## TT413: 2009 Touring Rear Fork Rusty Water Leakage

2009 Touring Rear Fork Rusty Water Leakage

Figure 2. Debris Deflector

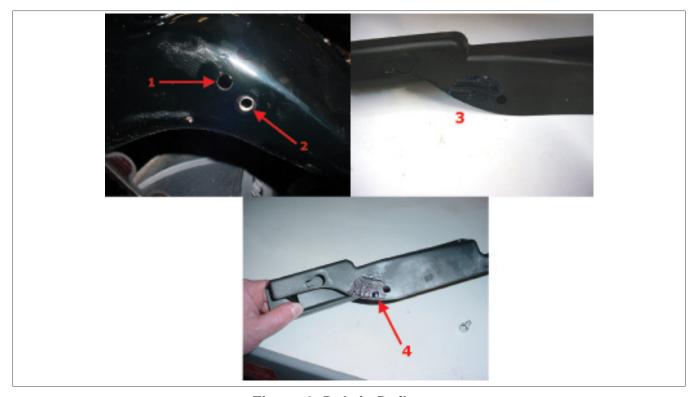
The potential water entry points are a forward facing drain hole (used in production) in the pivot shaft area, the two upper holes for the brake line retention clips, and the holes underneath the lower belt guard. On low mileage vehicles this may be residual after-wash from manufacturing's pre-paint procedure that did not boil out during the paint bake process, or it may be from external sources (puddles, washing, etc.) after the motorcycle was put into service. Dependant upon the amount of debris remaining inside the fork from the manufacturing process, and the fact the belt's debris deflector runs across the lower drain hole, it is possible for the water to build up and become contaminated. Add a few MPH to the equation along with the associated air flow and this stagnate water can slowly work its way out and onto the rear of the vehicle.

However, to ensure the condition does not continue we recommend opening up a clear escape path for the water to exit by:

- Removing the debris deflector
- 2. Marking the location of the swingarm's drain hole, using some grease to find the drain hole (just forward of the center mounting screw)
- 3. Drilling a 0.250" hole in the plastic debris deflector (not the swing arm), directly in line with the swingarm's drain hole
- 4. Clean the vehicle, if necessary
- 5. Reinstall the modified debris deflector
